Access Compliance Report

Public Rights-of-Way

Intersection ID: 2832	Main Street: GOLDENFIELD_DR	Cross Street: DEARVIEW_LN	Location:	N
ADA ID: 3F508A1D3406	Ramp Type: Perp	Initial Pass/Fail: Fail	Overall Compliance: No	Severity Score: 10

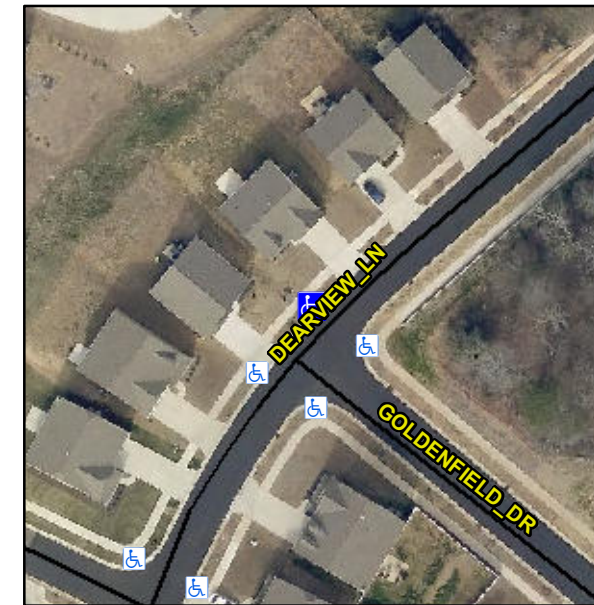
Not Found, R304.5.1, R304.5.3

Compliance	Description	Data	Compliance	Description	Data
N/A	Ramp Length (in)	69.0	Yes	Ramp Slope (%)	8.1
No	Ramp Width (in)	47.5	No	Ramp XSlope (%)	4.6
N/A	Flare Type LT	N/A	N/A	Flare Type RT	N/A
N/A	Flare Slope LT (%)	N/A	N/A	Flare Slope RT (%)	N/A
N/A	Flare Traversable LT?	N/A	N/A	Flare Traversable RT?	N/A
N/A	Landing Length (in)	N/A	N/A	DWS Provided?	N/A
N/A	Landing Width (in)	N/A	N/A	DWS Contrast?	N/A
N/A	Landing Slope (%)	N/A	N/A	DWS Length (in)	N/A
N/A	Landing X Slope (%)	N/A	N/A	DWS Full Width?	N/A
N/A	Landing Curb? (Y/N)	N/A	N/A	DWS Offset (in)	N/A
N/A	Shared Landing?	N/A			
N/A	Gutter Ponding?	N/A	N/A	Gutter Slope (%)	N/A
N/A	Gutter Lip Ht (in)	N/A	N/A	Gutter X Slope (%)	N/A
N/A	Painted X Walk1?	No	N/A	Painted X Walk2?	N/A
	X Walk 1 Direction	To SE		X Walk 2 Direction	N/A
N/A	X Walk 1 Width (in)	N/A	N/A	X Walk 2 Width (in)	N/A
	X Walk 1 Slope (%)	4.3		X Walk 2 Slope (%)	N/A
	X Walk 1 X Slope (%)	2.3		X Walk 2 X Slope (%)	N/A

Remove & Replace Entire Ramp.
